ASSESSMENT REPORT

SENIORS LIVING DEVELOPMENT 34-36 MEMORIAL AVENUE, KELLYVILLE MP 09_0180 (MOD 7)

Figure 5: Approved building layout (left) and proposed building layout (right) (source: original Project approval plans and Mod 7 application documents)

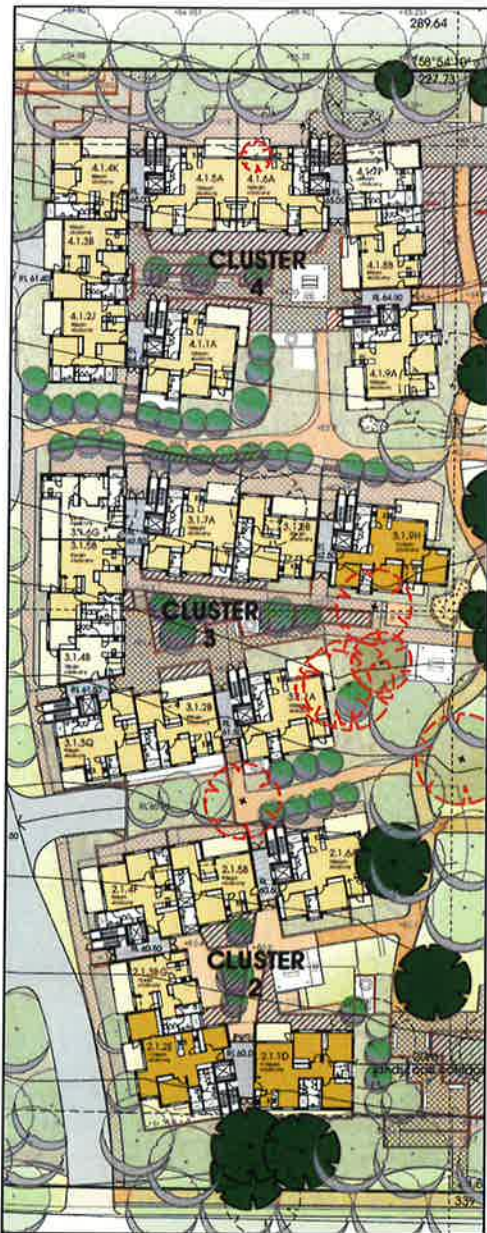
The Department considers the proposal would result in improved building separation compared to the current approval. As approved, Clusters 2, 3, and 4 included a floor plan arrangement where units were separated by small internal courtyards, approximately 12 metres in width (**Figure 4**). The proposed floorplate removes the internal courtyard and consolidates the building footprint, resulting in improved separation and amenity outcomes for the units.

Figure 13 – Proposed streetscape (eastern) elevation of Cluster 4 to Rutherford Avenue with outline of approved building shown in red (source: application documents)

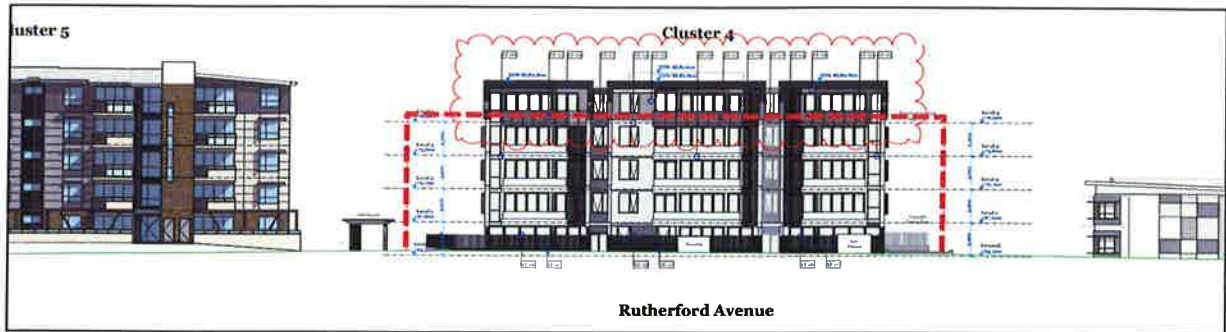
The Cluster 4 building has a primary frontage to Rutherford Avenue and would be visible from the street and properties to the east of the site. Compared to the approved building, the modified building would:

- be one storey taller
- present an overall height at the street front similar to that of Cluster 5 to the south and 3 stories taller than the RACF building to the north (see **Figure 13**)
- present a significantly narrower façade to the street with increased setbacks to Cluster 5 and the RACF building
- include a more contemporary façade design, presenting as three modules, separated by

recesses, creating the appearance of three separate buildings (see **Figure 14**).

- the height of both building would be consistent with the height of adjoining buildings to the south (see **Figures 11 and 13**)
- both buildings present a contemporary stepped façade which ensures the buildings would be highly modulated and give the appearance of three slender buildings rather than a bulky single building
- the range of materials and finishes, including different treatment of the ground and top floors, further add to the visual interest of the building
- both buildings would have greater side setbacks than the approved development allowing additional landscaping to be provided
- the proposed front setbacks of both buildings would still allow for appropriate landscaping to be provided which would soften the appearance of the buildings from the street.

Figure 15: Site layout showing building separation on the site (source: application documents)

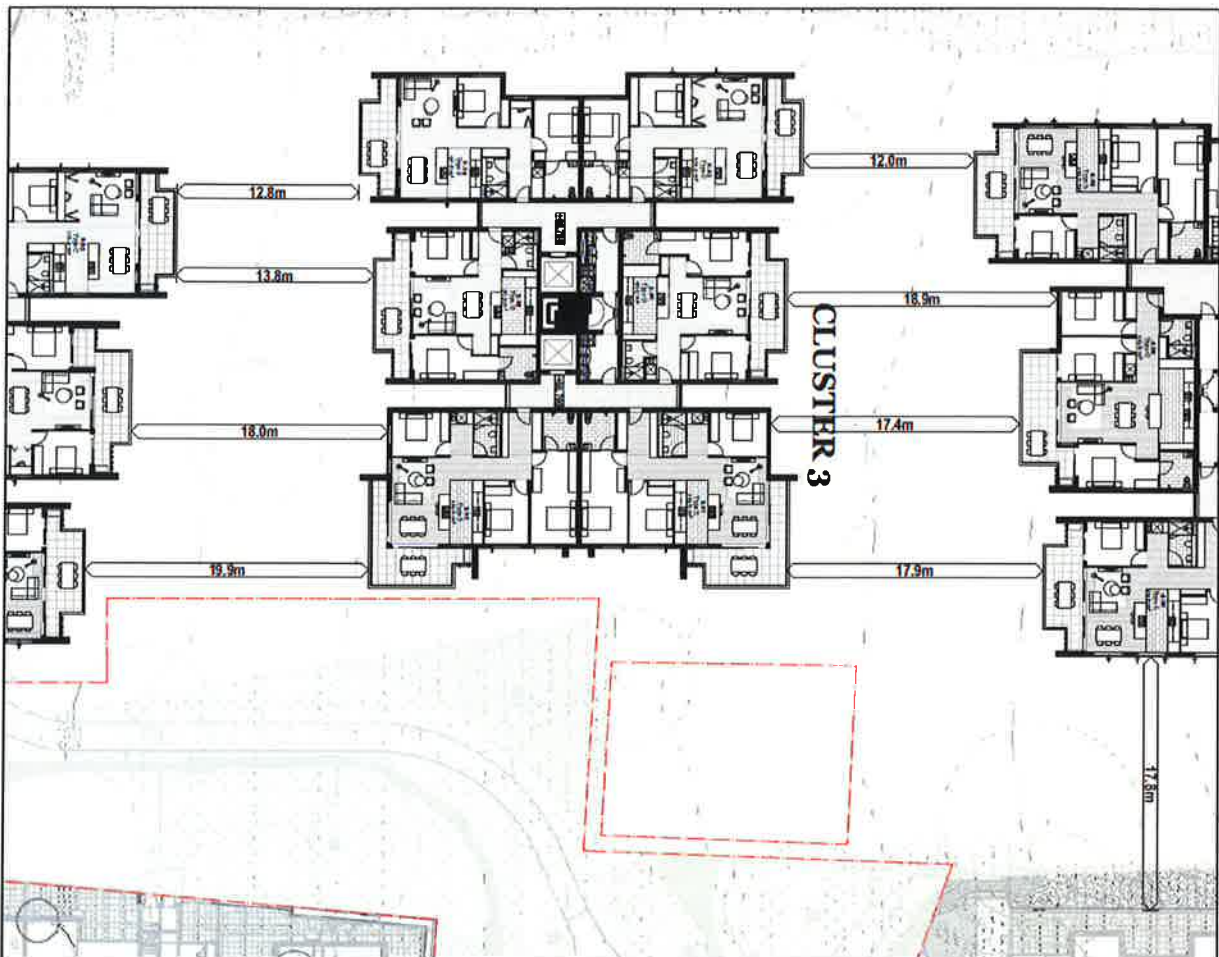
To minimise privacy impacts between apartments, the ADG recommends a minimum building separation of 12 metres for buildings up to 4 storeys in height and 18 metres for buildings 5 storeys and above. The proposed development complies with the separation requirements up to the fourth storey. However, the proposal does not comply with the 18 metre building separation requirement for the fifth storey, with building separation distances of:

- 12 m to 19.9 m between Clusters 2, 3 and 4

- 15.7 m - 17.0 m between Clusters 1 and 2
- 17.6 m - 17.7 m between Clusters 4 and 5.

The Proponent considers the non-compliances are minor and would not result in adverse visual privacy impacts, noting that:

- most units at the fifth storey exceed or come close to complying with the ADG requirements for building separation
- due to the site topography, there is a height difference between each building resulting in the upper west facing units being elevated so that they are not overlooked
- the difference in height between units (due to the site topography) helps minimise direct overlooking
- balconies on the fifth level have solid balustrades
- all apartments would have internal window coverings.

The revised building footprints also allow for improved separation between each of the clusters, including significant improvements for separation from Cluster 5 (from 8 -12 m separation as approved to 17.6 m as proposed). Given the generous building separation now proposed between Clusters 4 and 5, an existing condition requiring privacy measures to be provided

Figure 16: Section through the site showing proposed tree planting between the buildings (source: Mod 7 landscape plans)

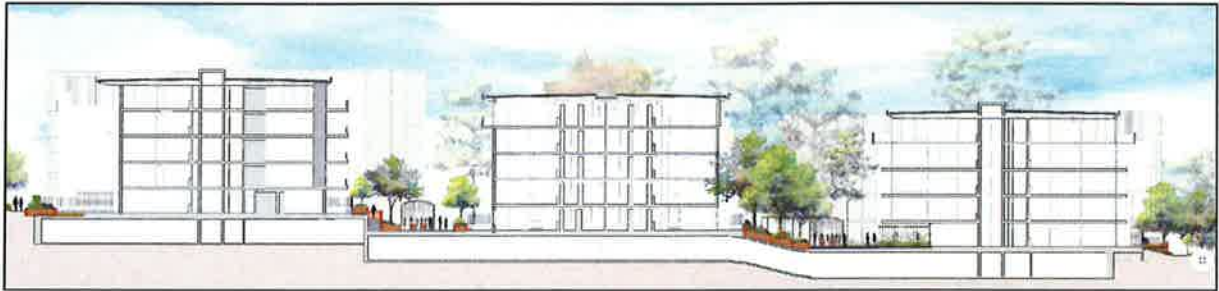
The separation between the buildings also allows for significant tree plantings between each of the clusters (**Figures 5 and 16**) which will provide additional visual screening. The Department therefore considers the proposed modified layout, with improved building separation outcomes, would result in unacceptable levels of amenity and privacy for residents.

Figure 17: Proposed site plan showing the existing unchanged boundary of the CPW area (purple), proposed additional CPW area (red), and proposed reduced CPW (yellow). Proposed additional CPW planting is delineated by yellow circles (*source: application documents*)

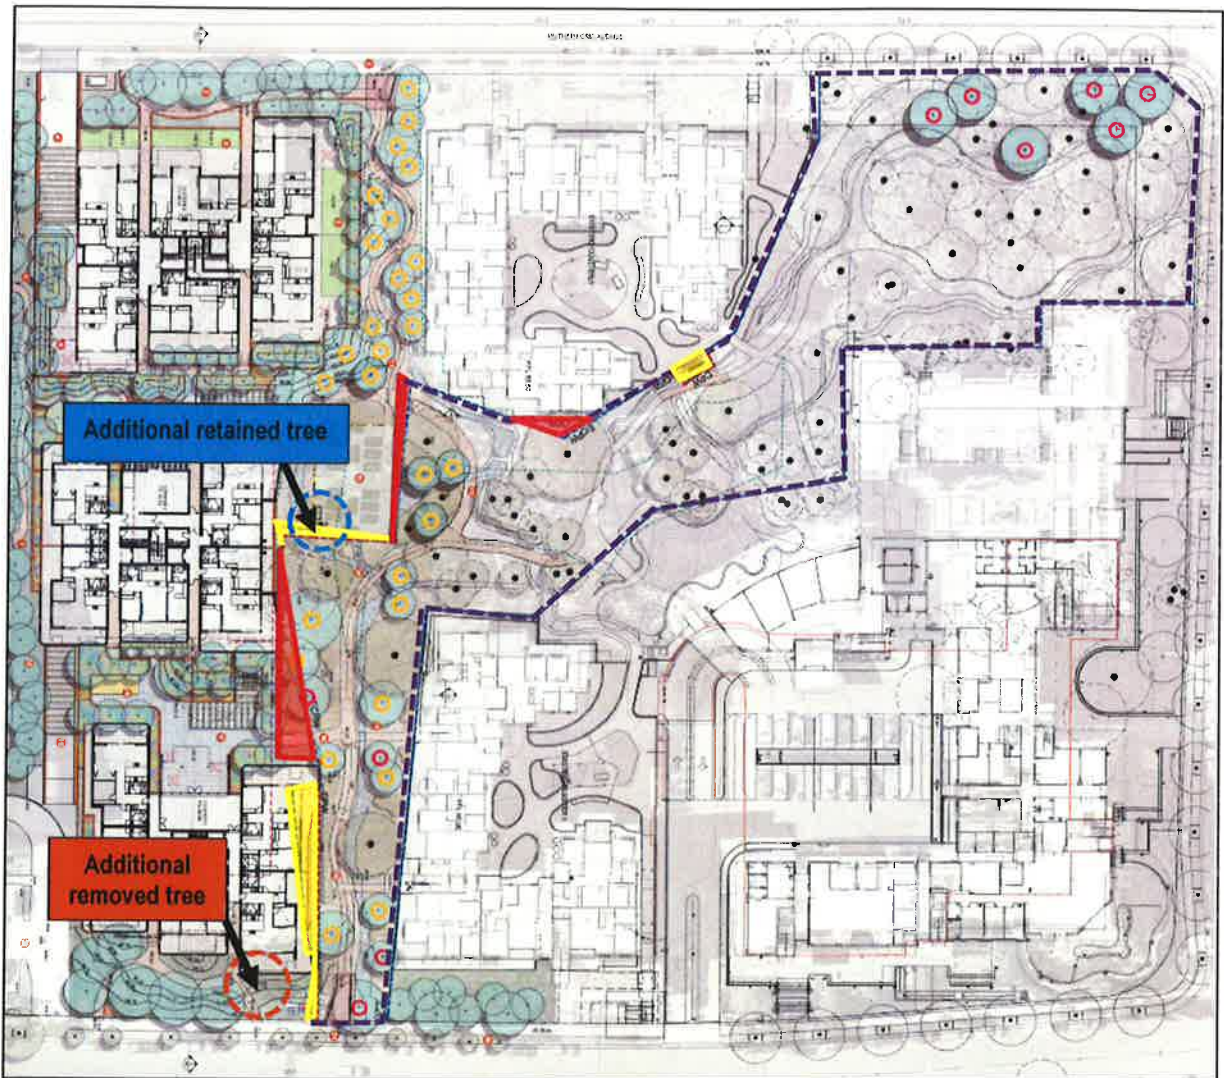
The Section 88B Instrument has been registered. However, it is proposed to be slightly altered to reflect the proposed changes to the building footprints. The change in the CPW boundary is shown in **Figure 17**. The overall size of the protected CPW area would remain unchanged at 0.56 ha as all boundary changes which reduce the CPW area (shown in yellow) are offset by other areas of increased CPW (shown in red). The changes to the boundaries of the CPW also do not affect tree retention within the CPW area.

Council raised no objection to the modified CPW boundary but noted the restriction on title should be updated to reflect the change in the CPW boundary. A condition has been included in the recommendation to this effect.

OEH raised no objection to the modified CPW boundary and supported the retention of the additional tree. However, it initially requested that consideration be given to whether the footprints can be amended to retain the additional tree now proposed for removal, or any other trees previously approved for removal. It also requested that trees to be removed (including those with hollows) be sensitively dismantled, protected and reused in the CPW area and nest boxes be monitored on an ongoing basis.

The Department considers the measures proposed by the Proponent, including provision of 28 new CPW trees, provision of natural hollows and ongoing monitoring would significantly improve biodiversity values on the site compared to the current approval. Conditions have therefore been recommended to ensure the additional measures are incorporated into the approval accordingly.
